Flintshire LDP Inquiry 2021 – Weeks 5 and 6 Submission statements.

Cllr David Williams and Pen-y-ffordd Community Council.

Pen-y-ffordd Village – Candidate sites and alternative sites for housing.

LDP - Proposed Changes to County Plan - Green Barrier Pen-y-ffordd & Penymynydd

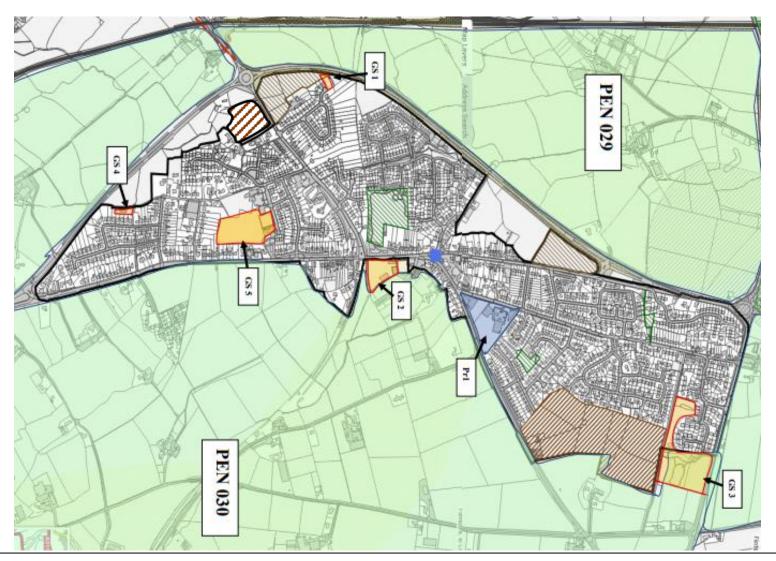
**PEN 029 & PEN 030.** These proposals have not been designated as Green Barrier in the proposed plan. In order to protect this semi-rural settlement, it is believed that these proposals should be added to the final plan.

- **GS 1, 2, 3 and 4.** These locations noted on the map are village play spaces and need to be added to the plan. Particular attention needs to be paid to GS1 that is a current play space that is being extended as part of the Rhos road development!
- **GS 5** This is the shared community play space that needs to be added to the plan for protection.
- **PR 1** This is the old school site as referred at iii in the representation and needs to be protected from development.
